## Change to Gulper IC wiring

**DATE:** 24<sup>th</sup> May 2013

Figure 1: MK2 wiring diagram - negative override switch

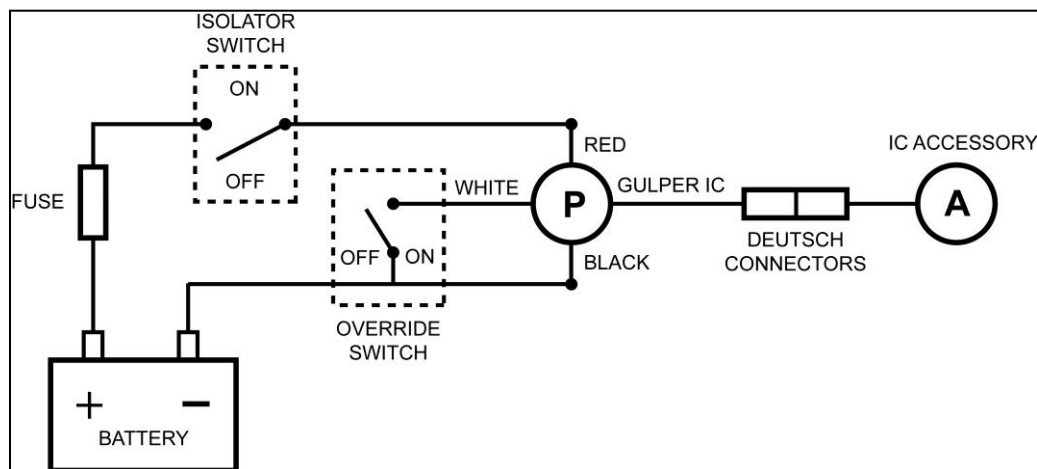
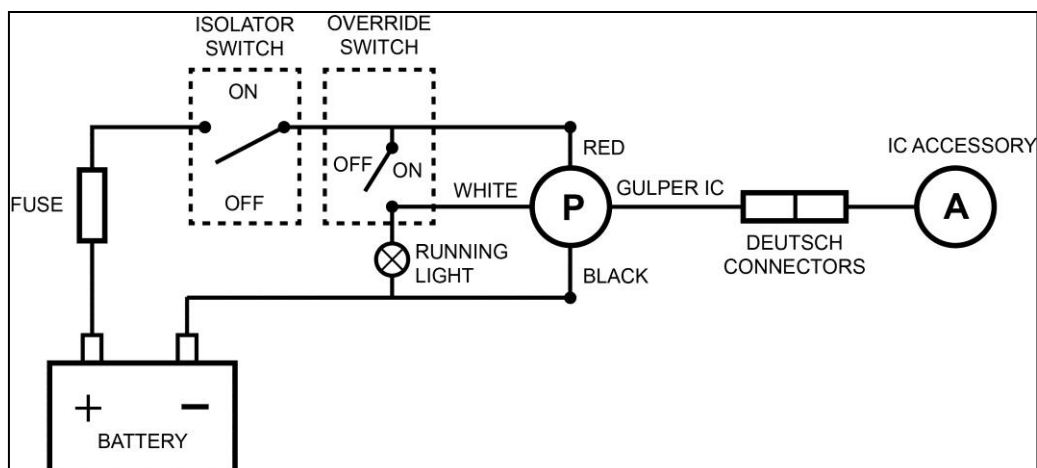
The difference between MK2 and MK3 is the wiring of the override switch. Figure1 shows the previous method to connect the Gulper IC pump to the battery. Figure2 shows the new MK3 wiring connections, note the change of position of the override switch.
